RESPONSE TO COMMENTS

City of Ketchikan – Charcoal Point Wastewater Treatment Plant NPDES Permit AK0021440

Figure 1. Plot of Monthly Average Effluent TSS Data for January 2020 to March 2025

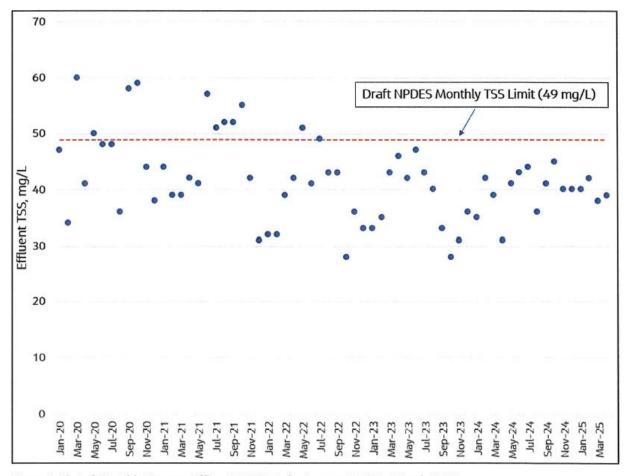
Ketchikan used Charcoal Point WWTP monthly average effluent TSS concentration data for January 2020 to March 2025 to develop the plot shown in Figure 1 below. This plot of monthly average effluent TSS concentrations demonstrates that the proposed revised monthly average TSS effluent limit (49 mg/L) presented in the Draft NPDES Permit is likely to be exceeded. These TSS data show that the proposed revised monthly average TSS effluent limit (49 mg/L) was exceeded 17% of the time in recent years.

NPDES Permit Comment #3 (Table 1)

Ketchikan is requesting that the revised monthly average TSS effluent limit be set at no lower than 60 mg/L. Ketchikan is also requesting that a new footnote be included in Table 1 in the NPDES permit stating the following: 'Effluent BOD5 and TSS limits were calculated based on past removal performance and not the 30% removal effectiveness required in Section 301(h) of the Clean Water Act, and these effluent limits may be revised or increased up to the minimum 30% removal effectiveness required in the Clean Water Act without triggering anti-backsliding conditions."

Response 3

During permit development the EPA typically evaluates the past five years of effluent data, which corresponds with the five-year NPDES permit cycle in 40 CFR 122.46. To better assess the performance of the Ketchikan WWTP over a longer period, the EPA requested data for all weekly TSS samples collected at the facility since 2015, which demonstrated effluent variability that was not captured in only reviewing the past 5 years of data. To account for this variability, the EPA calculated new performance-based TSS limits that are representative of the discharge over a 10-year period. The new TSS performance-based limits are:

Concentration Limits

Average Monthly: 56 mg/L

Average Weekly: 81 mg/L

The EPA has incorporated these recalculated limits in the final permit at Permit Part I.B.1. – Table 1. See Appendix A for the concentration-based TSS limit calculations and data.
